2001 M2/S3 SHIFT LINKAGE KIT

The purpose of this bulletin is to announce the release of the **new** M2/S3 Shift Linkage Kit and to provide installation instructions.

Figure 1. Shift Linkage

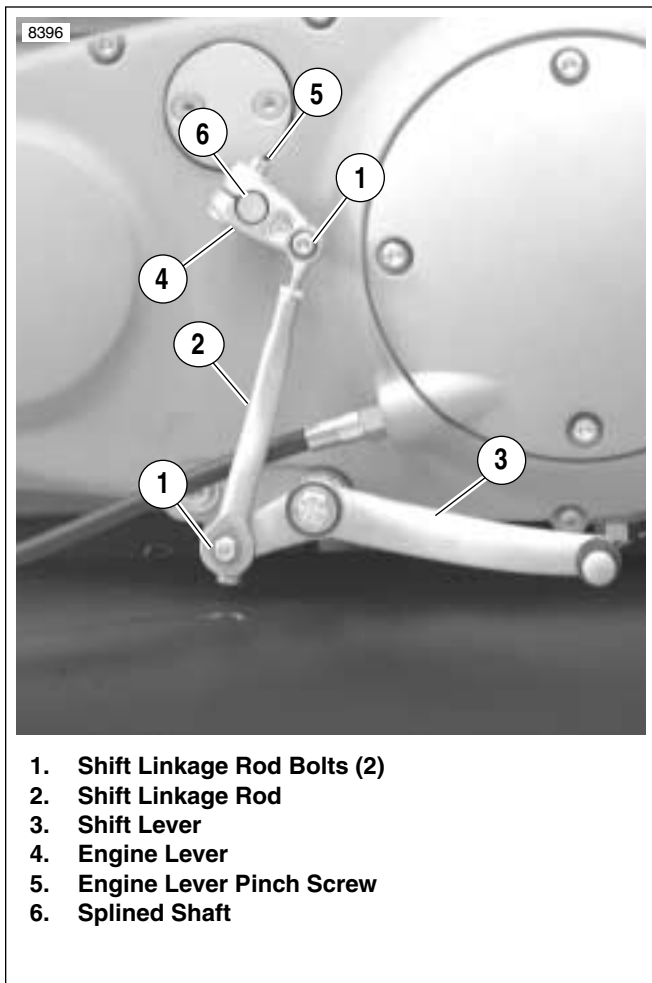
1. See [Figure 1](#). Remove upper and lower shift linkage rod bolts (1). Remove shift linkage rod (2) from shift lever (3) and engine lever (4).
2. Remove pinch screw (5) and engine lever (4) from splined shaft (6). Discard engine lever (4), shift linkage rod (2) and hardware (1 and 5).

1. See "A" in [Figure 3](#). Position **new** engine lever on splined shaft oriented as shown in figure (pointing just below front clutch inspection cover bolt). Lower figures "B" and "C" are examples of incorrect clamp orientation.
2. See [Figure 1](#). Apply LOCTITE THREADLOCKER 243 (Blue) to pinch screw and install in engine lever.
3. See [Figure 1](#). Tighten engine lever pinch screw to 59-66 **in-lbs** (7-8 Nm).

Figure 2. Shift Linkage Rod Length

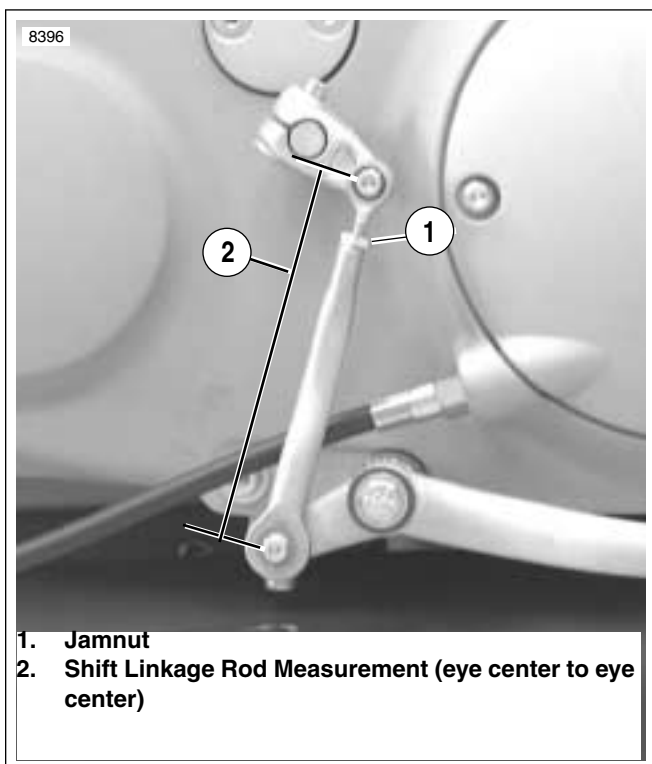
4. See [Figure 2](#). Shift linkage rods are preset to the factory length of 4.75 in. (121 mm). Adjust shift linkage rod length as required to suit rider preference. Maximum allowable shift linkage rod length is 4.88 in. (124 mm).
 - a. Loosen jamnut (1) and rotate top eye clockwise to shorten or counterclockwise to lengthen.
 - b. Tighten jamnut when complete.
5. Apply LOCTITE THREADLOCKER 243 (Blue) to upper and lower shift linkage rod bolts and install shift linkage rod with two bolts.
6. Tighten shift linkage rod bolts to 59-66 **in-lbs** (7-8 Nm).
7. Check for proper shift linkage/clutch operation.
